SHINE MEDICAL TECHNOLOGIES, LLC

**SHINE MEDICAL TECHNOLOGIES, LLC OPERATING LICENSE APPLICATION
SUPPLEMENT NO. 5 AND RESPONSE TO REQUEST FOR ADDITIONAL INFORMATION**

**RESPONSE TO REQUEST FOR ADDITIONAL INFORMATION
PUBLIC VERSION**

Figure 13a2.2-1 – Radiological Consequence Assessment

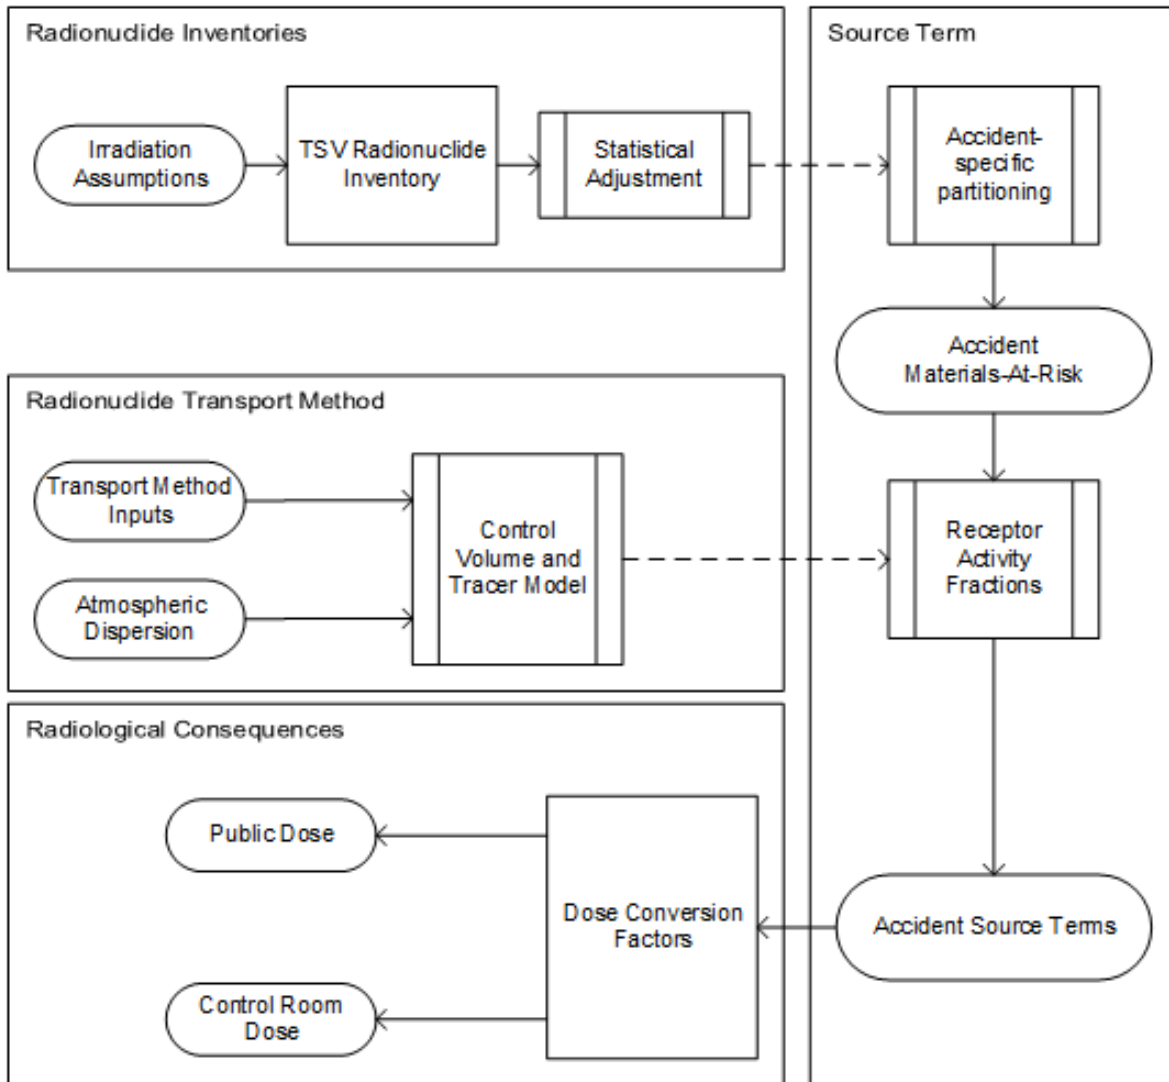
The radiological consequence assessment is a multi-step process. [Figure 13a2.2-1](#) provides a graphical representation of the process, which is further described in this section. The process involves: (1) calculation of radionuclide inventories, (2) definition of the accident-specific materials-at-risk (MAR), (3) transport methods of radionuclides, (4) development of accident source terms, and (5) determination of radiological consequences.
